TRANSMITTAL LETTER

**Revisions to
Traffic Standards – Signals TC-8800 Series
December 2011 Edition, Change No. 1**

TRAFFIC STANDARDS—SIGNALS TC-8800 SERIES

PUB 148 (6-23)

SHEET 1 OF 10
 TC-8801

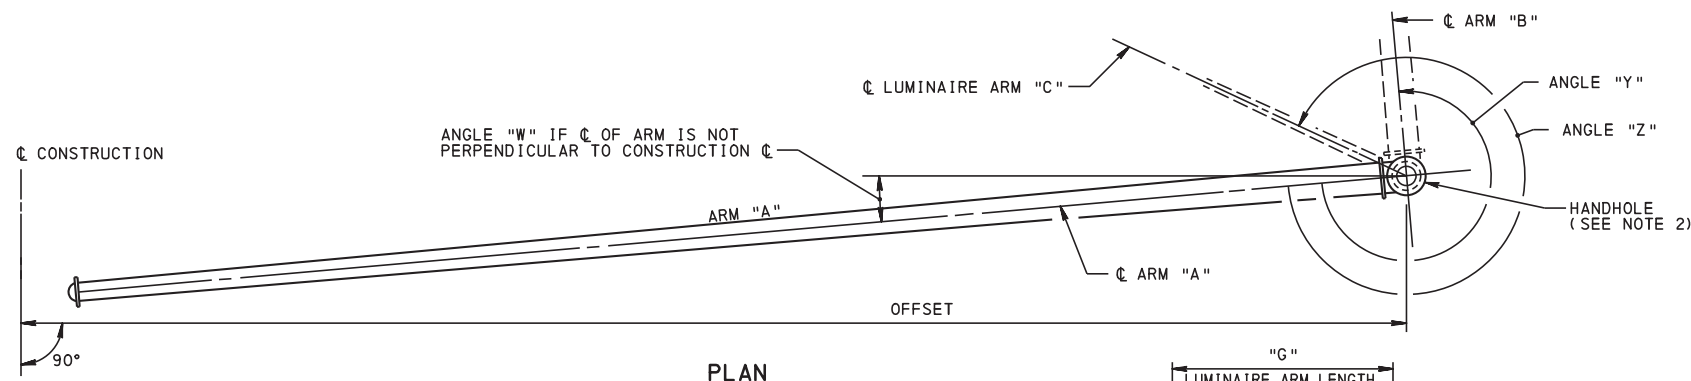
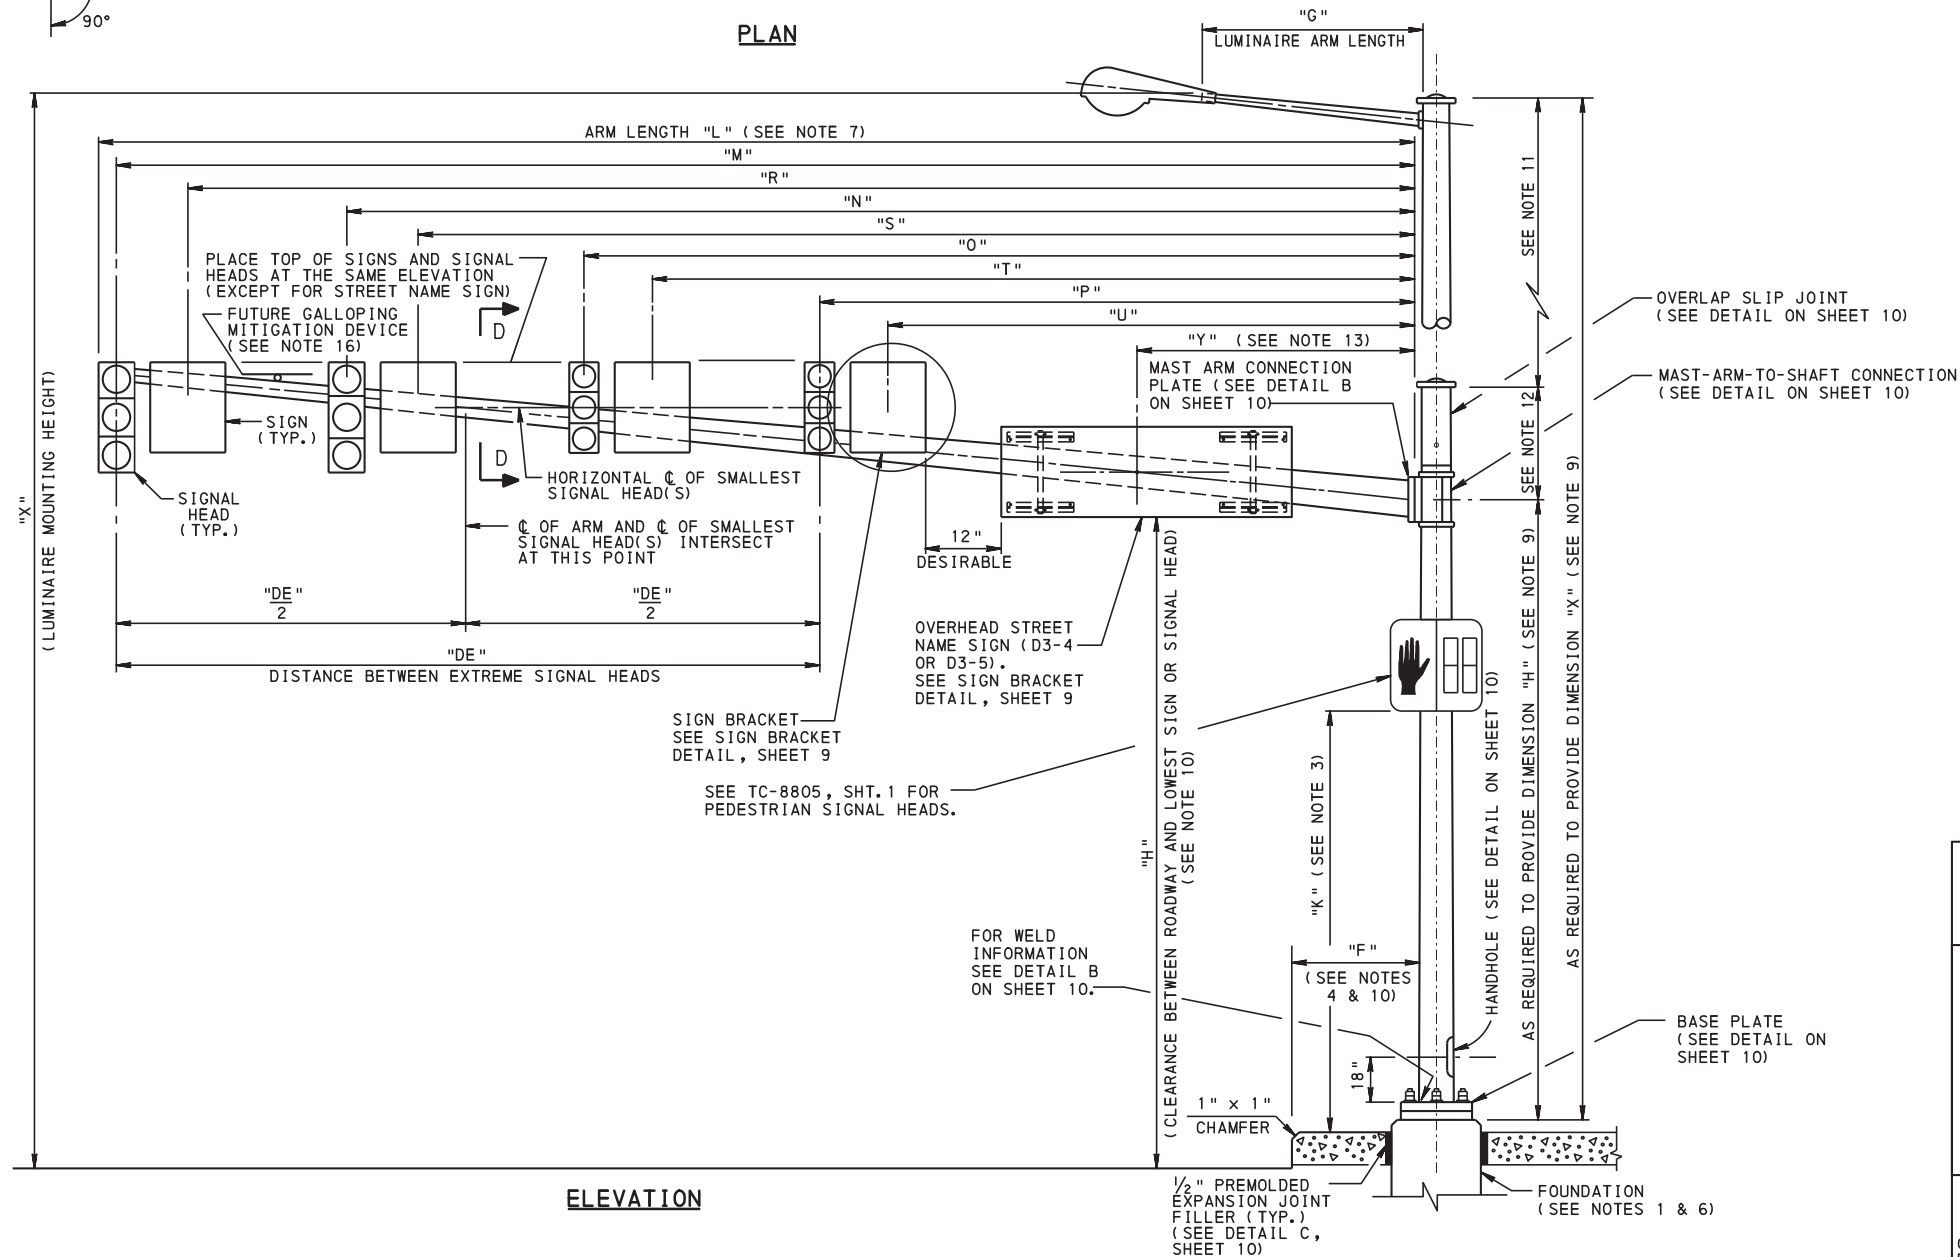
STANDARD	SHEET	DESCRIPTION OF CHANGES
TC-8801	1	<p>Updated Mast Arm Details as follows:</p> <ul style="list-style-type: none"> -Revised Handhole callout leader location on Plan View of mast arm to match location of handhole depicted in Elevation View -Revised bolt pattern on Elevation View of mast arm pole base plate. Bolts depicted now represent six bolt pattern implemented in 2011 TC-8801 updates. <p>Updated Notes as follows:</p> <ul style="list-style-type: none"> • Revised Note 7 from “ARMS LESS THAN 31’ WILL BE ONE SECTION” to “ARMS 30’ OR LESS WILL BE ONE SECTION” • Revised second sentence of Note 16 from “PROVIDE GALLOPING MITIGATION DEVICE IN ACCORDANCE WITH PUB 408, SECTION 1104.02(b) IF THE MAXIMUM DISPLACEMENT (MAX. POSITIVE TO MAX. NEGATIVE) AT THE MAST ARM TIP EXCEEDS 8”.” to “PROVIDE GALLOPING MITIGATION DEVICE IN ACCORDANCE WITH MITIGATION DEVICE DETAIL ON SHEET 10 IF THE MAXIMUM DISPLACEMENT (MAX. POSITIVE TO MAX. NEGATIVE) AT THE MAST ARM TIP EXCEEDS 8”.”

SHEET 2 OF 10
TC-8801

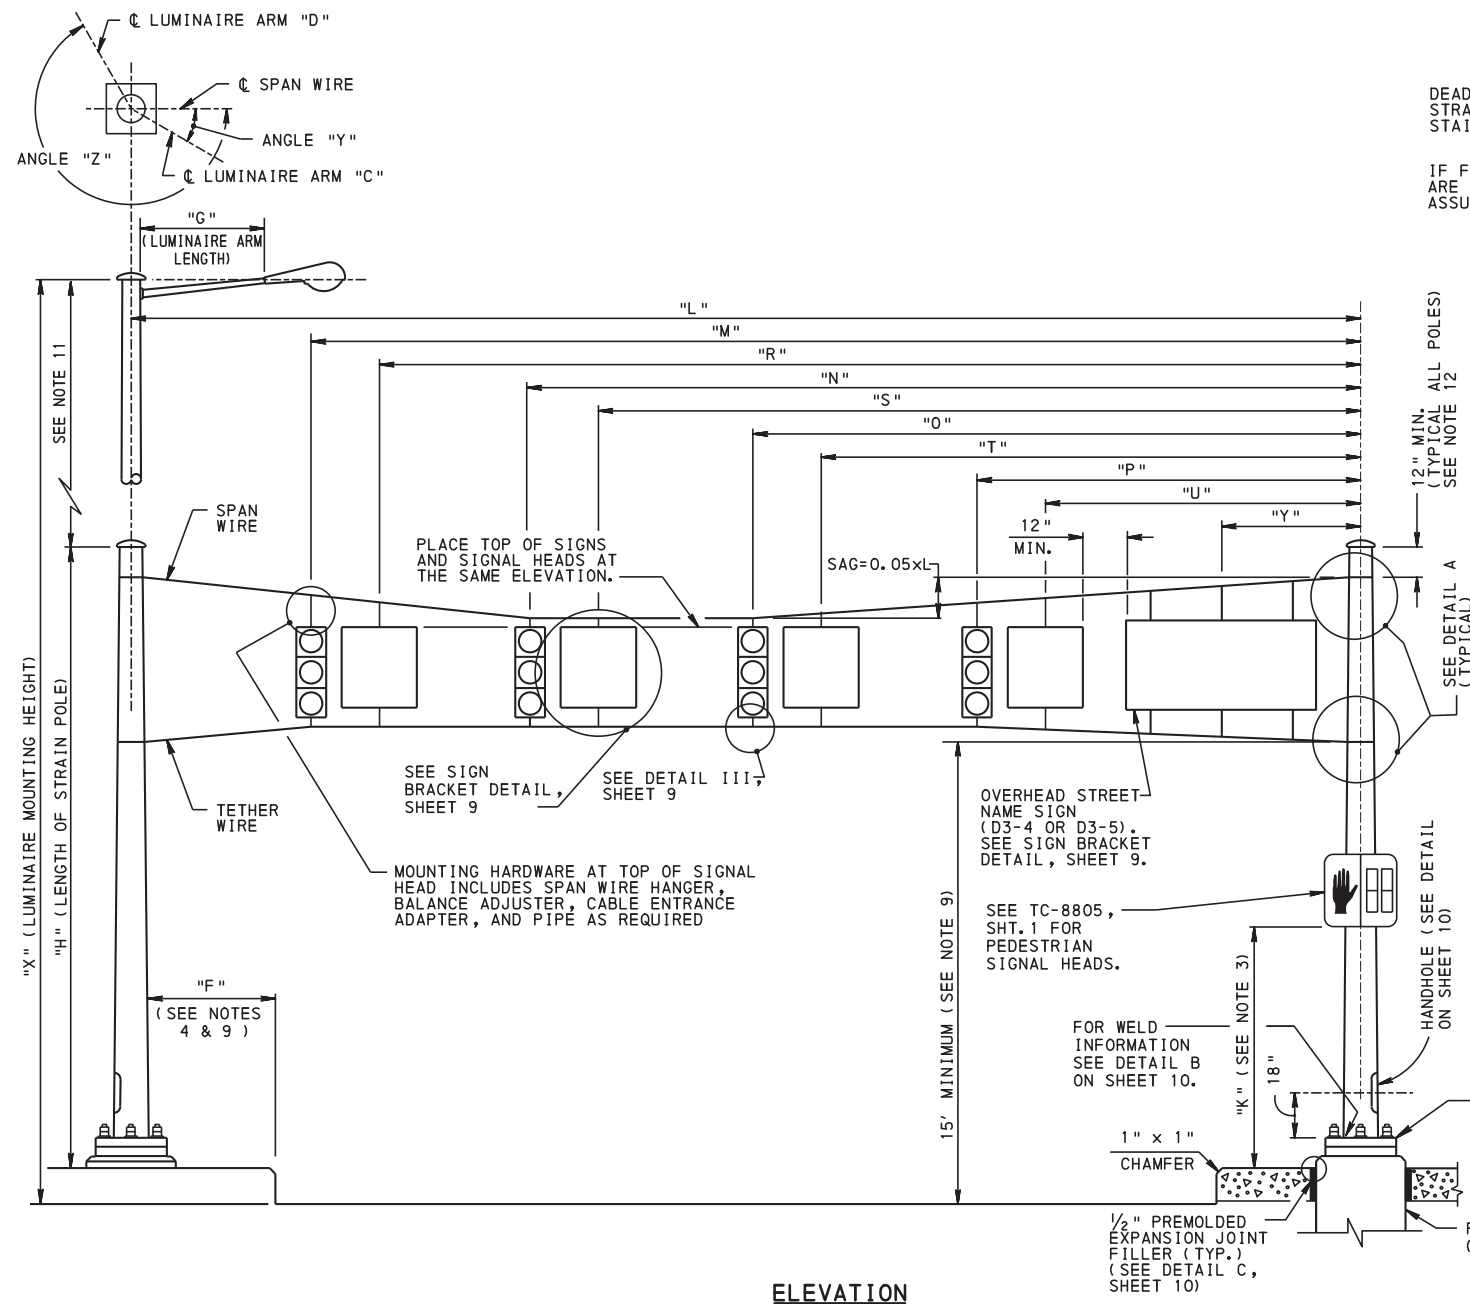
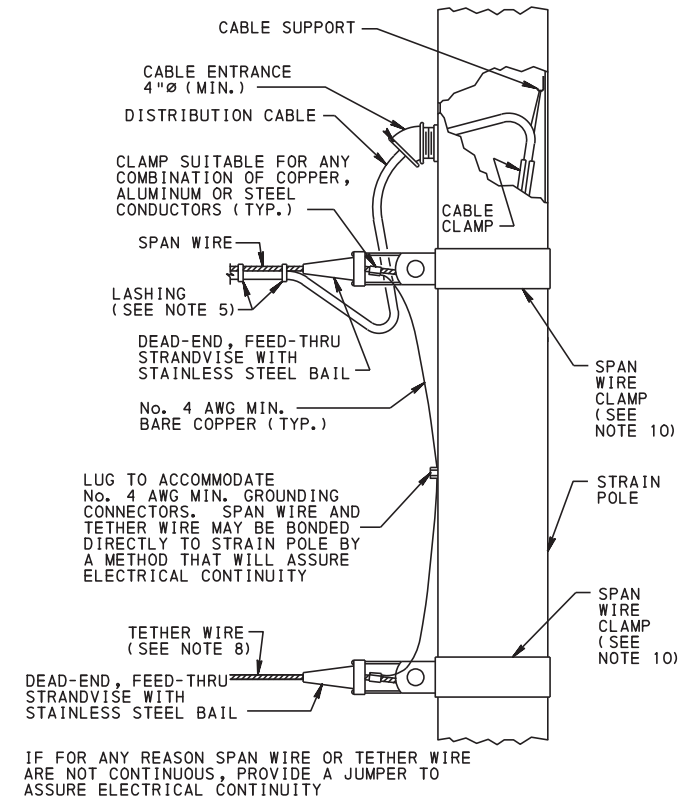
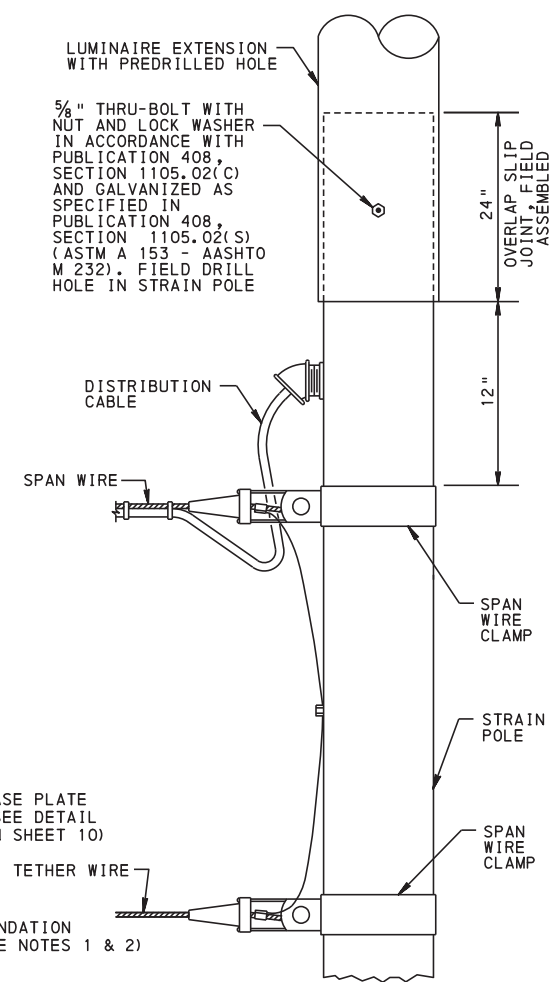
TC-8801	2	<p>Updated Strain Pole Details as follows:</p>

SHEET 3 OF 10

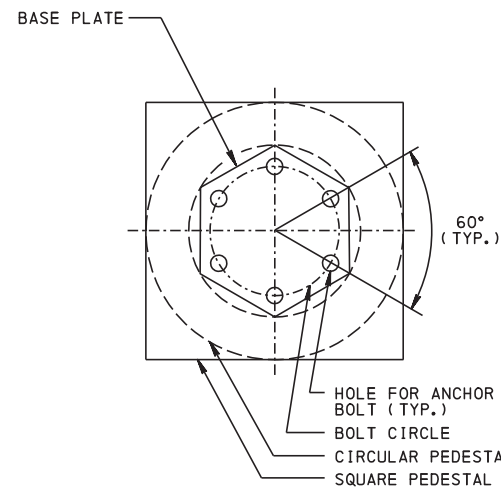
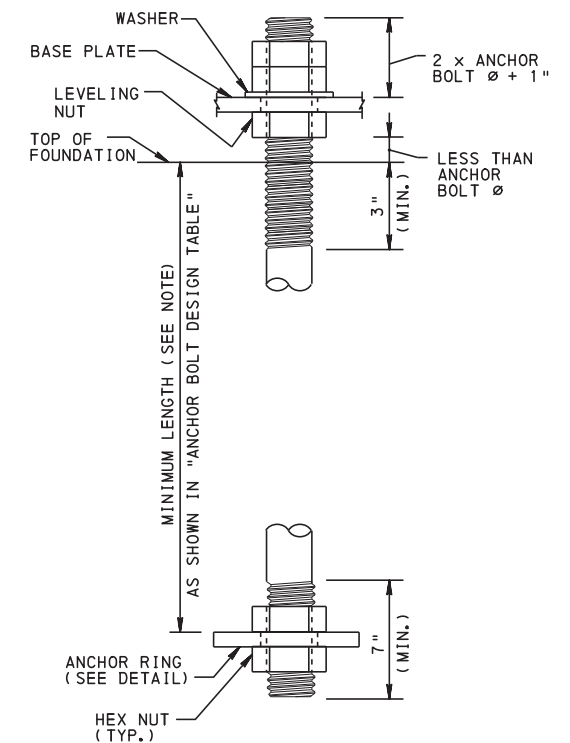
TC-8801	3	<p>-Revised bolt pattern on Elevation View of strain pole base plates. Bolts depicted now represent six bolt pattern implemented in 2011 TC-8801 updates.</p> <p>Updated Foundation Notes as follows:</p> <ul style="list-style-type: none"> • Revised Note 7 from “GALVANIZE ALL STRUCTURAL STEEL IN ACCORDANCE WITH PUB. 408, SECTION 1104.02(a) 8.” to “GALVANIZE ALL STRUCTURAL STEEL IN ACCORDANCE WITH PUB. 408, SECTION 951.2(c)1.d” • Revised Note 10 from “USE STEEL TEMPLATE TO SET ANCHOR BOLTS IN ACCORDANCE WITH PUBLICATION 408, SECTION 1104.02 (e).” to “USE STEEL TEMPLATE TO SET ANCHOR BOLTS IN ACCORDANCE WITH PUBLICATION 408, SECTION 951.2(c)5.” 	
TC-8801	4	<p>Updated Type A Foundation Case 1 Section F-F Detail as follows:</p> <p>-Removed “(SEE NOTE 5)” from “GALVANIZED WIRE MESH OR GROUT” callout .</p> <p>Updated Notes as follows:</p> <ul style="list-style-type: none"> • Revised the first sentence of Note 3 from “IN A PAVED AREA, PLACE THE TOP OF FOUNDATION FLUSH WITH THE SURFACE OF THE ADJACENT PAVEMENT” to “IN A SIDEWALK AND PAVED AREA, PLACE THE TOP OF FOUNDATION FLUSH WITH THE SURFACE OF THE ADJACENT PAVEMENT” • Removed Note 5 • Renumbered Notes 6, 7, and 8 to Notes 5, 6, and 7 respectively

STANDARD
TRAFFIC SIGNAL SUPPORT
FOUNDATION TYPE B

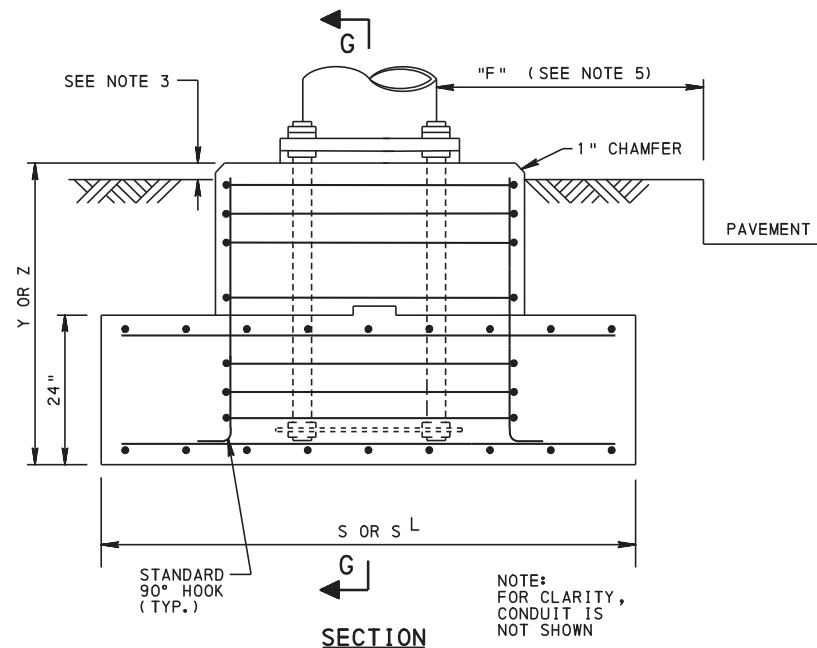
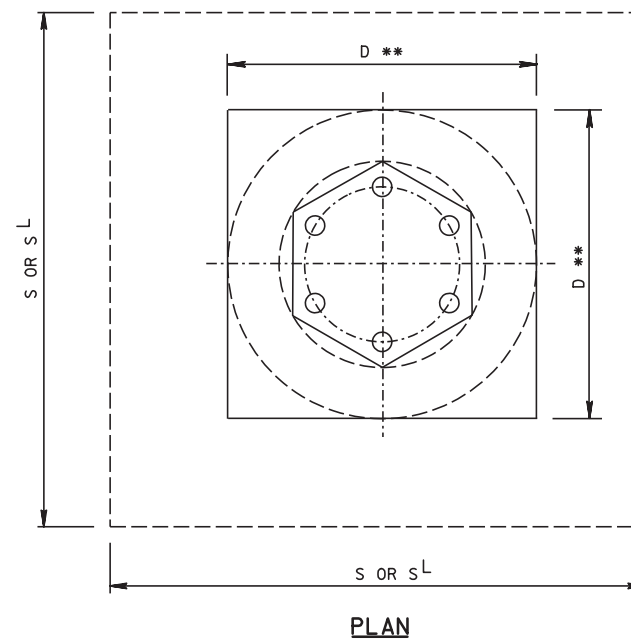
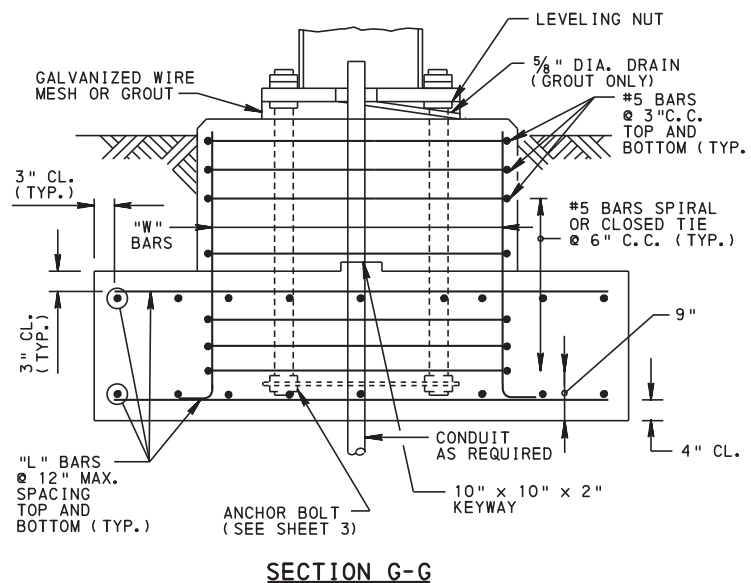
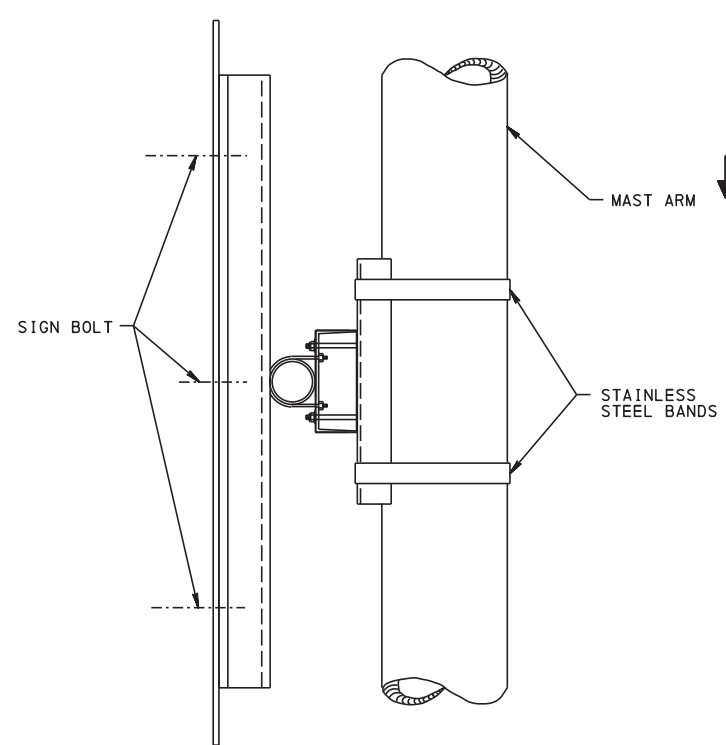
TC-8801	8	<p>Updated Type B Foundation Section G-G Detail as follows:</p> <p>-Removed “(SEE NOTE 7)” from “GALVANIZED WIRE MESH OR GROUT” callout .</p> <p>Updated Notes as follows:</p> <ul style="list-style-type: none"> • Revised the first sentence of Note 3 from “IN A PAVED AREA, PLACE THE TOP OF FOUNDATION FLUSH WITH THE SURFACE OF THE ADJACENT PAVEMENT” to “IN A SIDEWALK AND PAVED AREA, PLACE THE TOP OF FOUNDATION FLUSH WITH THE SURFACE OF THE ADJACENT PAVEMENT” • Removed Note 7 • Renumbered Note 8 to Note 7 	
TC-8801	9	<p>Updated Sign Bracket – Mast Arm Detail as follows:</p> <p>-Revised “STAINLESS STEEL BAND CONFORMING TO PUBLICATION 408, SECTION 1103.11(n).” callout to “STAINLESS</p>
